Access Compliance Report Public Rights-of-Way (Curb Ramps)

Main Street: GERSHON_PL Cross Street: GRAMERCY_DR Location: SW

ADA ID: RPAT211025113505 Ramp Type: Type 1 - Perpendicular Diagonal Initial Pass/Fail: Pass Overall Compliance: No Severity Score: 26

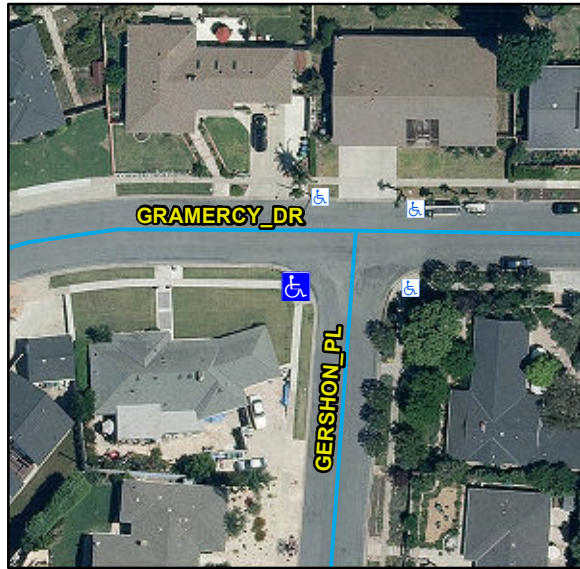
Compliance	Description	Data	Compliance	Description	Data
N/A	Ramp Length (in)	112	N/A	Flare Type LT	
Yes	Ramp Width (in)	48			Sloped
Yes	Ramp Run Slope (%)	8.2	N/A	Flare Slope LT (%)	6.2
Yes	Ramp Cross Slope (%)	0.8	N/A	Flare Traversable LT	No
N/A	Landing Present	No	N/A	Flare Type RT	
N/A	Landing Length (in)	N/A			Sloped
No	Landing Width (in)	N/A	N/A	Flare Slope RT (%)	5.1
No	Landing Run Slope (%)	N/A	N/A	Flare Traversable RT	No
No	Landing Cross Slope (%)	N/A	No	DWS Provided	No
N/A	Landing Movement Obstructed?	No	N/A	DWS Contrast	N/A
	Landing Movement Type	N/A	N/A	DWS Length (in)	N/A
N/A	Landing Shared	N/A	N/A	DWS Full Width	N/A
N/A	Clear Space	Yes	N/A	DWS Offset Left (in)	N/A
N/A	Clear Space To Crosswalk (in)	48	N/A	DWS Offset Right (in)	N/A
N/A	Marked Crosswalk 1	No	N/A	Marked Crosswalk 2	No
	Crossing 1 Direction	SE		Crossing 2 Direction	NE
	Marked Crosswalk 1 Width (in)	N/A		Marked Crosswalk 2 Width (in)	N/A

N/A	Ramp Inside Crosswalk 1	N/A	Yes	Ramp Inside Crosswalk 2	N/A
	Crossing 1 Slope (%)	3		Crossing 2 Slope (%)	2.3
	Crossing 1 Cross Slope (%)	0.7		Crossing 2 Cross Slope (%)	0.8
Yes	Gutter Ponding	No	No	Curb Slope	5.5
Yes	Gutter Lip Height (in)	0		Road Run Slope (%)	0.2
No	Gutter Run Slope (%)	5.9		Road Cross Slope (%)	4.5
Yes	Gutter Cross Slope (%)	0.2			
Yes	Overall Surface Condition: Acceptable		No	Perp Joint Present	No
	Cross Gutter Present?	Yes		Spandrel Present?	Yes
	Replace Cross Gutter?	No		Replace Spandrel?	No

Remove & Replace Curb Ramp With Two New Directional Ramps or Equivalent. Remove & Replace Gutter.
